VIRGINIA ELECTRIC AND POWER COMPANY
RICHMOND, VIRGINIA 23261

VIRGINIA ELECTRIC AND POWER COMPANY
NORTH ANNA POWER STATION UNIT 2
ALTERNATIVE REPAIR TECHNIQUES-RELIEF REQUESTS NDE-048 and NDE-049
REQUEST FOR ADDITIONAL INFORMATION

**Response to NRC Request for Additional Information
Relief Request NDE-048 and NDE-049
North Anna Power Station Unit 2**

**REQUEST TO USE EMBEDDED FLAW REPAIR TECHNIQUE
NORTH ANNA POWER STATION UNIT 2 RELIEF REQUEST NDE-048**

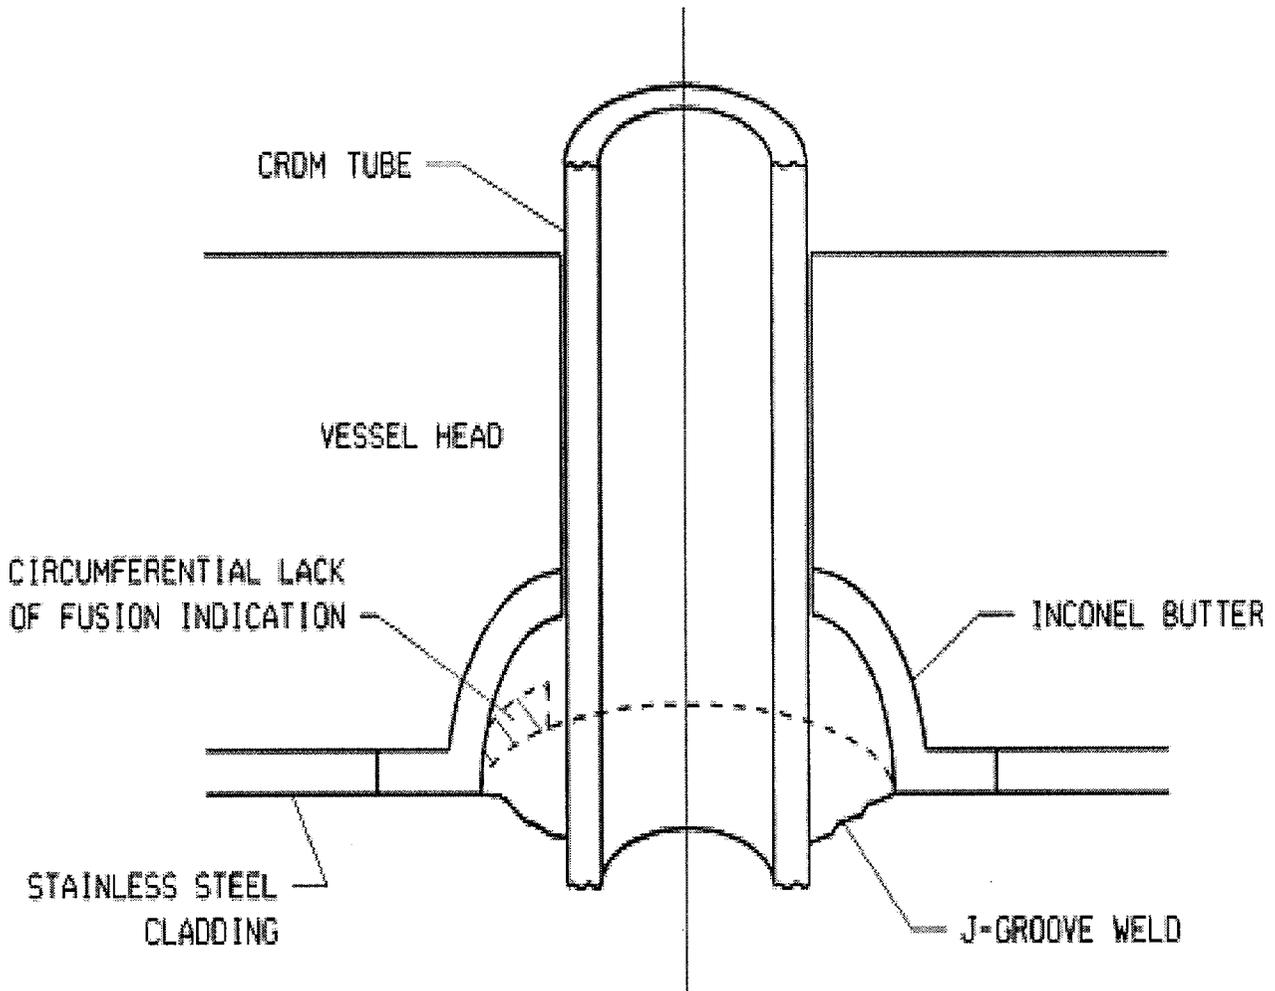
In Section V (page 4) of the submittal, there is a discussion on a postulated circumferential OD flaw in the J-groove weld. Provide a sketch of this crack configuration.

Response
